**ALBERTA TRANSPORTATION SPRINGBANK OFF-STREAM RESERVOIR PROJECT
RESPONSE TO NRCB AND AEP SUPPLEMENTAL INFORMATION REQUEST 1, JULY 28, 2018**

Natural Resources Conservation Board
May 2019

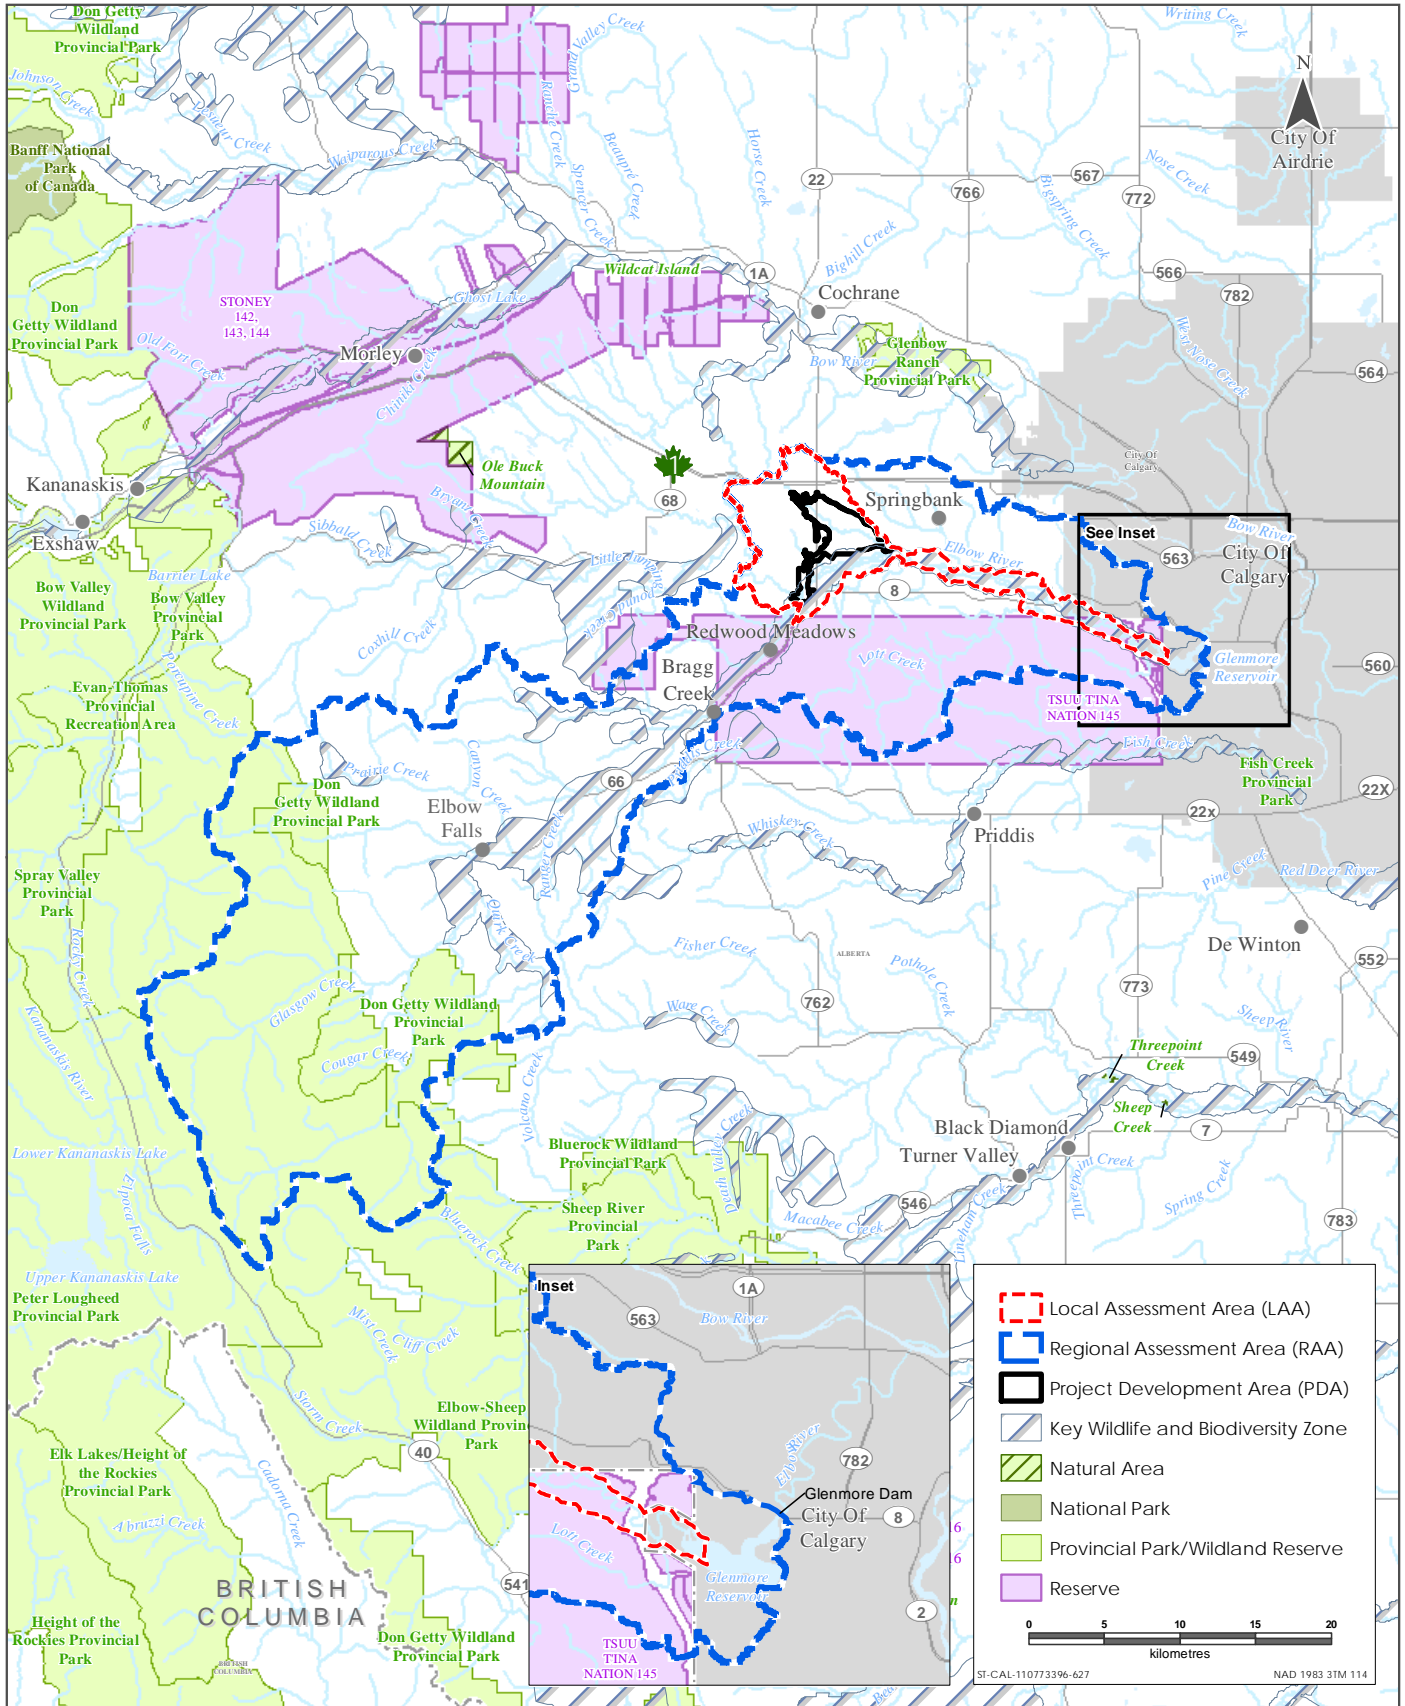
Alberta Transportation states that the LAA included the PDA and the Elbow River from Redwood Meadows to the inlet of Glenmore Reservoir (Volume 3A 6.1.4.1), that the LAA extends from the diversion structure...(Appendix J, 2.1). In Figure 6-1 (which is used again in various sections) it appears it may start below Redwood Meadows (i.e., inlet structure) and that the LAA may include the Glenmore Reservoir.

Alberta Transportation states that the RAA is the Elbow River watershed from headwaters to Glenmore Dam (Volume 3A, 6.1.4.1), that the RAA is the Elbow River watershed, including Glenmore Reservoir (Appendix J, 2.1), and Figure 6-1 appears to include the entire watershed, including the Glenmore Reservoir and upstream and downstream of the Glenmore Reservoir.

Volume 3A, Section 6, Figure 6-1 is incorrect; see Figure IR54-1 in the response to IR54 for the correct boundary of the LAA for both the hydrology and water quality LAA. The LAA includes Elbow River to the inlet of Glenmore Reservoir but does not include Glenmore Reservoir.

By diverting flow greater than 160 m³/s, the hydrology of Elbow River between the Project site and Glenmore Dam is jointly managed by AEP and the City of Calgary. The control of hydrology downstream of Glenmore Dam is under the sole control of the City of Calgary. Therefore, the hydrology RAA for the Project does not extend downstream of Glenmore Dam. Volume 3A, Figure 6-1 is incorrect for the boundary of the hydrology RAA. Figure IR54-1 shows the correct boundary.

Volume 3A, Figure 7-1 shows an incorrect boundary for the surface water quality RAA. Figure IR54-1 is also a correction to Figure 7-1.

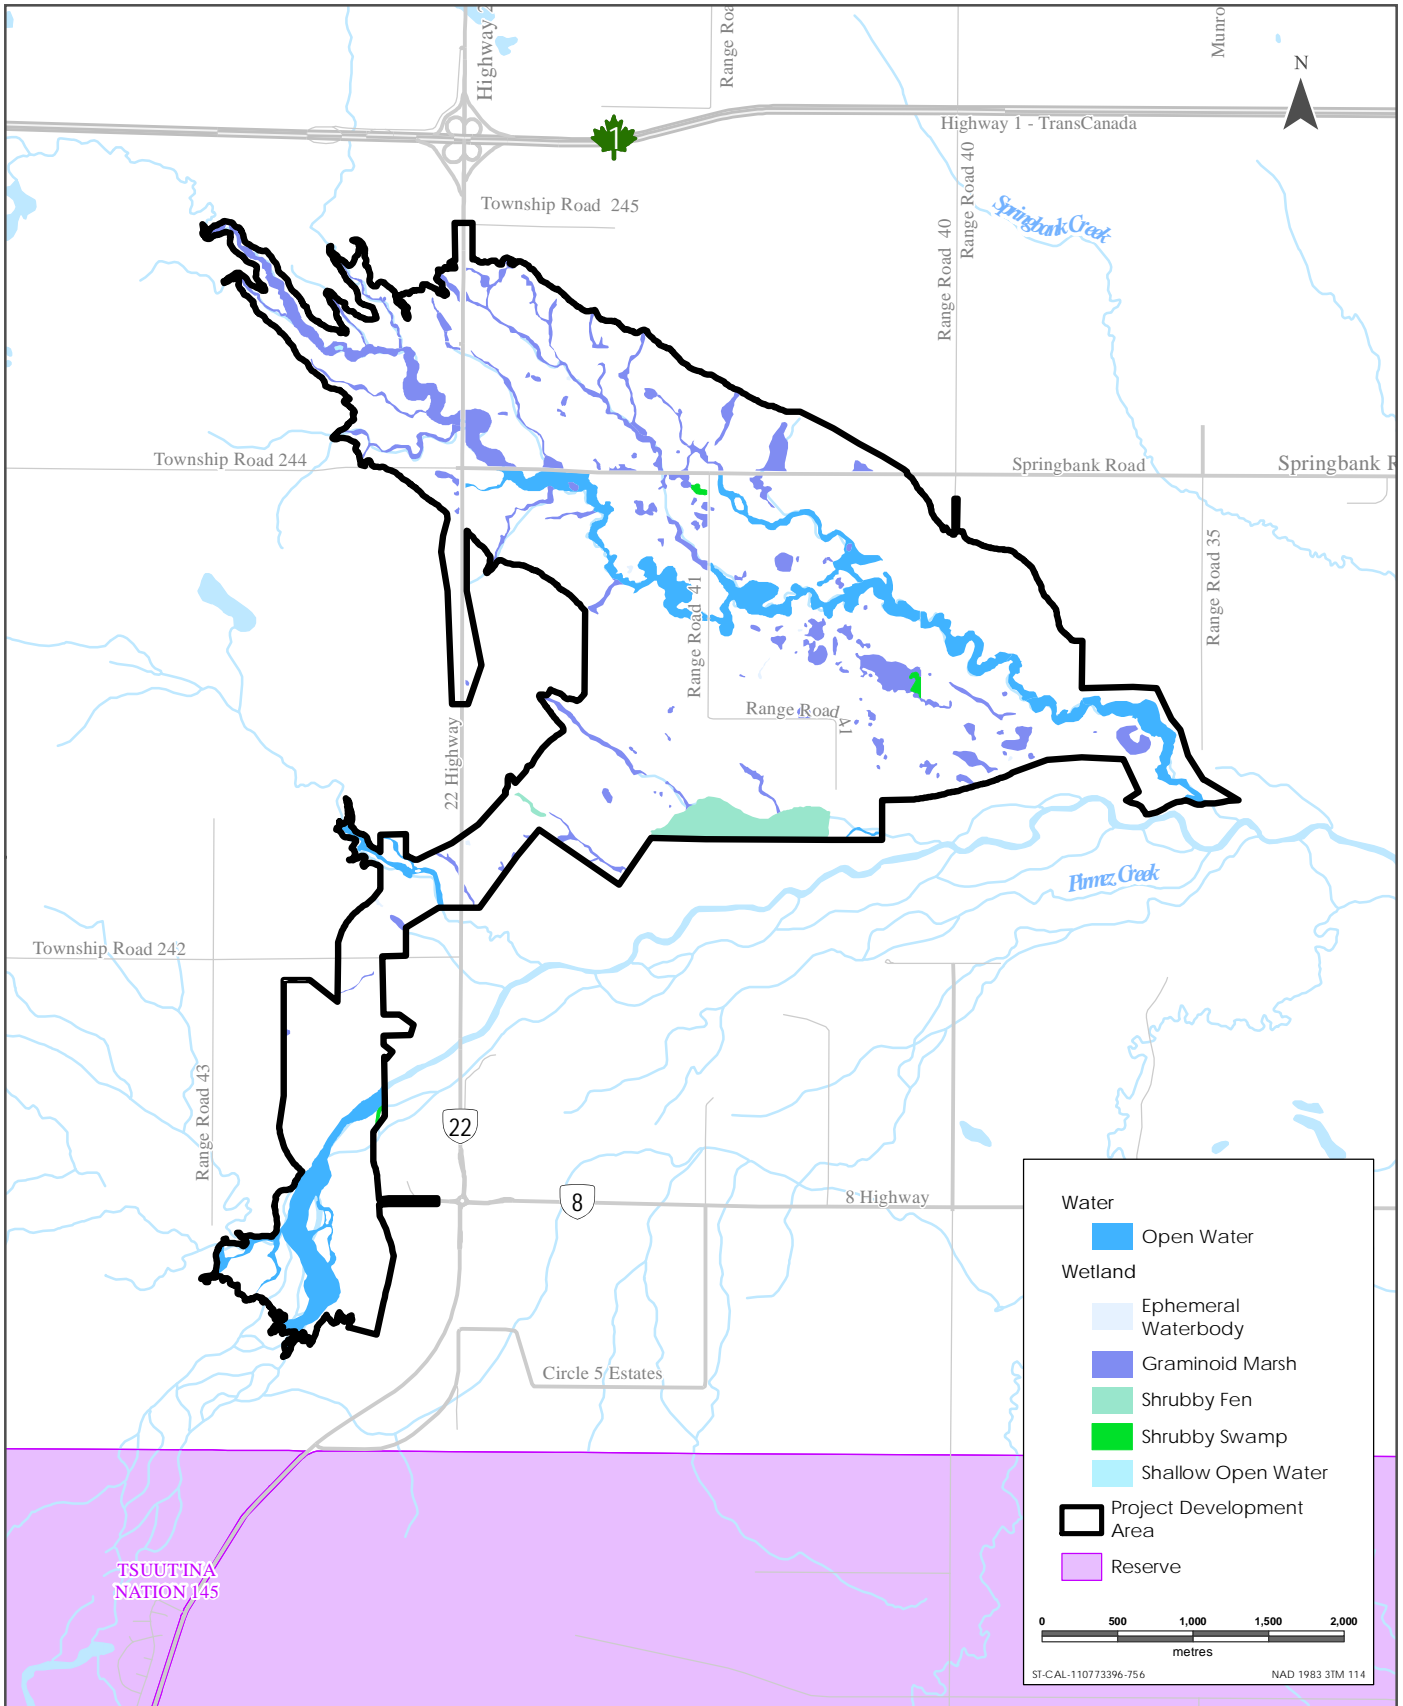
- a. Confirm that these waterbodies are primarily fed by the unnamed creek and its tributaries.
b. Provide a figure identifying the approximate areas of these waterbodies.

- a. Yes, these waterbodies are primarily fed by the unnamed creek (low-level outlet channel) and its tributaries.
b. Figure IR57-1 shows the locations of the waterbodies (including wetlands). The total area of the shown waterbodies is 225 ha.
